Service Bulletin

MEB09-2

MAIN LANDING GEAR TORQUE TUBE LIFE LIMIT

Figure 1. MLG Torque Tube Replacement (Sheet 1)

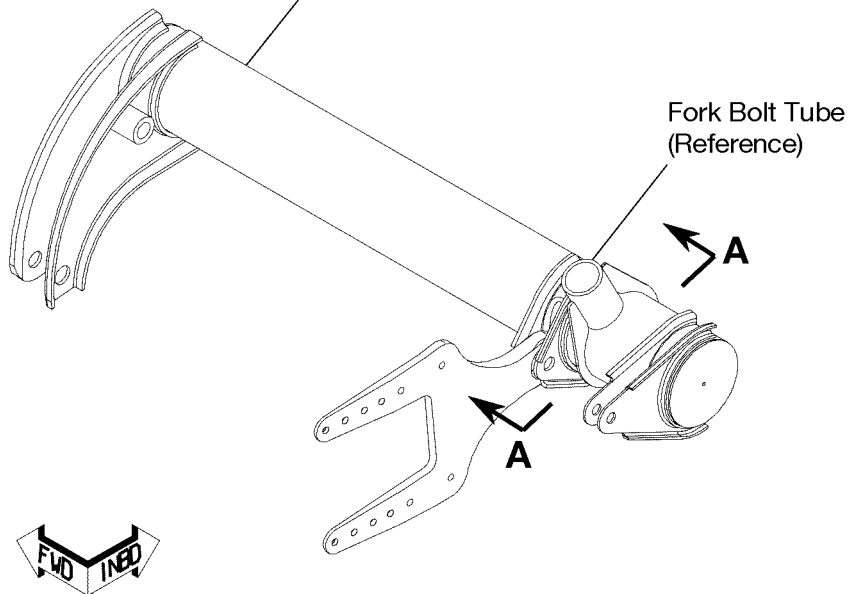
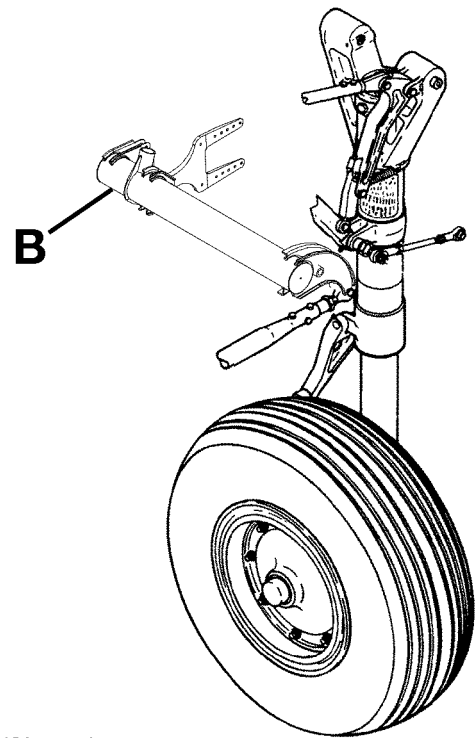
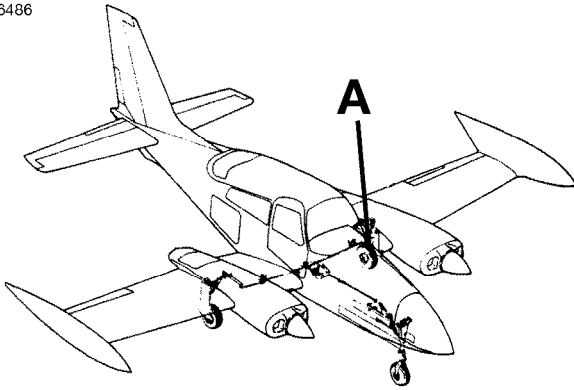
- B. (Refer to Figure 1, View A-A.) Examine the brace on the fork bolt tube.
 - (1) If there are no braces on the tube, the torque tube assembly installed on your airplane is not a 5045010-32 Right Torque Tube Assembly or a 5045010-33 Left Torque Tube Assembly. Go to Step 5.

- (3) If there are two braces on the tube, go to Step 4C.
 - C. Measure the outer diameter of the fork bolt tube:
 - (1) If the outer diameter of the tube is approximately 0.91 inch, the torque tube assembly installed on your airplane is a 5045010-32 Right Torque Tube Assembly or a 5045010-33 Left Torque Tube Assembly. Go to Step 9.

- (2) If the outer diameter of the tube is approximately 0.68 inch, the torque tube assembly installed on your airplane is not a 5045010-32 Right Torque Tube Assembly or a 5045010-33 Left Torque Tube Assembly. Go to Step 5.

5. Return the airplane to service as follows:
- A. Put the airplane on jacks. (Refer to the applicable section of the service/maintenance manual.)
 - B. (Refer to Figure 1, Detail A and Detail B.) Remove the 5045010 Torque Tube Assembly from the airplane. Keep the attachment hardware, but discard the nuts and the cotter pins. (Refer to the applicable section of the service/maintenance Manual.)

6. Install the 5045010-32 Right Torque Tube Assembly (5045010-33 Left Torque Tube Assembly) with the kept attachment hardware.
 - A. Do a visual inspection of the kept hardware that attaches the torque tube assembly to the outboard push-pull tube, uplock push-pull tube, support, 5027002-5 Support Bracket Assembly, and outboard drive tube.

- (1) If the kept hardware is in serviceable condition, keep it.
 - (2) If the kept hardware is not in serviceable condition, discard it.
 - B. Install the 5045010-32 Right Torque Tube Assembly (5045010-33 Left Torque Tube Assembly) to the outboard push-pull tube, uplock push-pull tube, support, outboard drive tube, and 5027002-5 Support Bracket Assembly with the new nuts and cotter pins and the kept or new washers and bolts in accordance with the applicable Illustrated Parts Catalog. (Refer to the applicable section of the service/maintenance manual.)
